Revised Transportation Memo

RE: Transportation Assessment for the
Revised Sunset & Western Mixed-Use Development Project
Hollywood, California

From: Wes Pringle <wes.pringle@lacity.org>
Sent: Tuesday, January 11, 2022 5:34 PM
To: Milena Zasadzien <milena.zasadzien@lacity.org>
Cc: William Lamborn <william.lamborn@lacity.org>; Emily Wong <ewong@gibsontrans.com>
Subject: Revised Sunset & Western Mixed-Use Development

REVISED PROJECT SITE PLAN

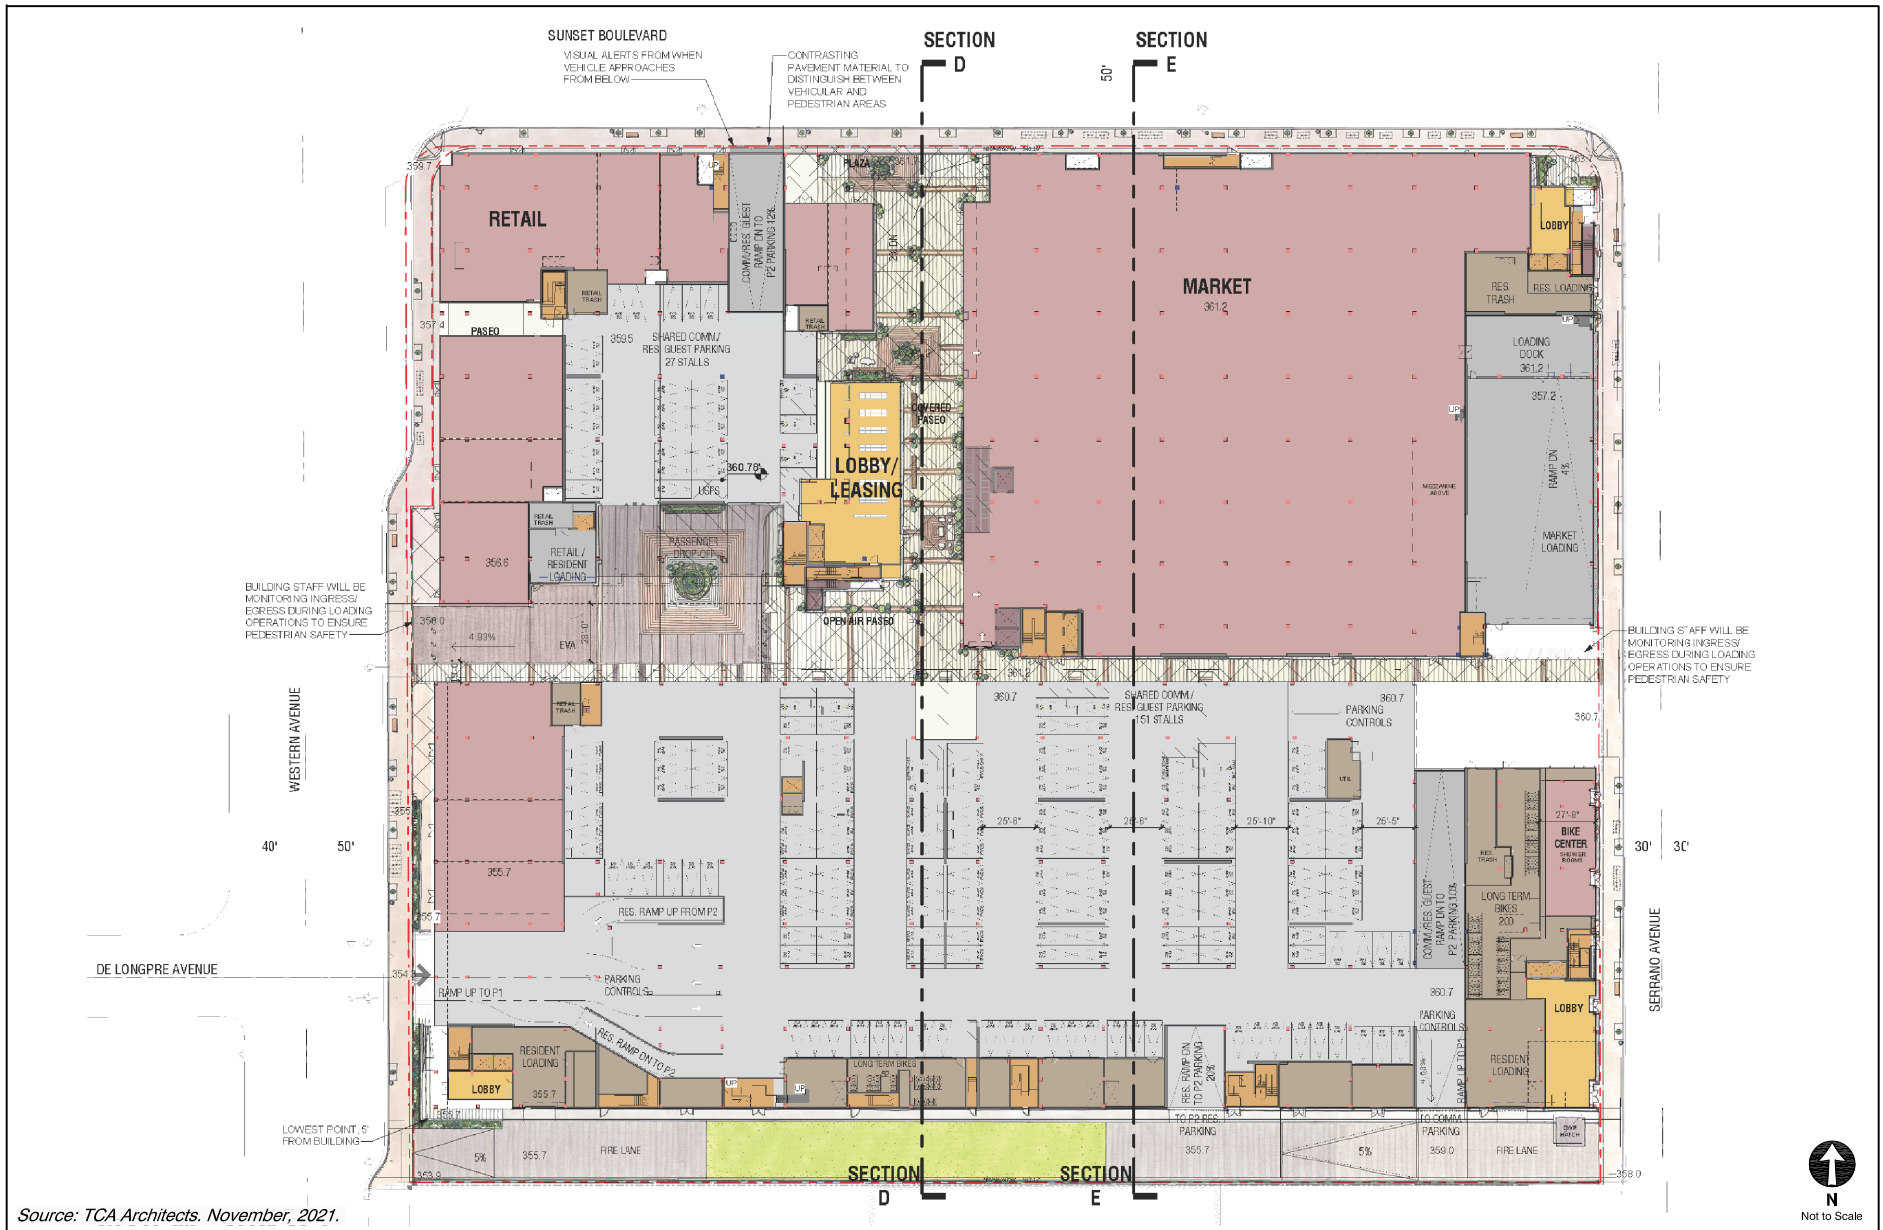
Additionally, there have been further changes to the access and circulation (latest site plan attached). The project would continue to provide driveways along Sunset Boulevard, Western Avenue, and Serrano Avenue. The revised project has relocated the fire lane to the southern boundary of the site and would extend between Western Avenue and Serrano Avenue. Additional emergency access would be provided midblock between Sunset Boulevard and De Longpre Avenue. The revised project would consolidate vehicular access along Western Avenue to a single residential/commercial driveway aligned with the new traffic signal at the intersection of Western Avenue and De Longpre Avenue. The midblock driveway along Serrano Avenue would provide full access to the commercial area and the fire lane driveway would provide access to the residential area. The driveway along Sunset Boulevard would continue to provide limited access (left and right-turn ingress and right-turn only egress) to the commercial area.

The supermarket loading dock has been modified to contain all turning maneuvers on-site, accessed off the commercial driveway along Serrano Avenue. There are other loading areas throughout the site as well. All loading areas will be managed with a dock manager and deliveries will be limited to off-peak hours.

DOT concurs with the CEQA analysis of the revised project that there are no new impacts introduced as a result of the changes. Therefore, all of the conditions of DOT last assessment letter, dated August 27, 2020, shall remain in effect.
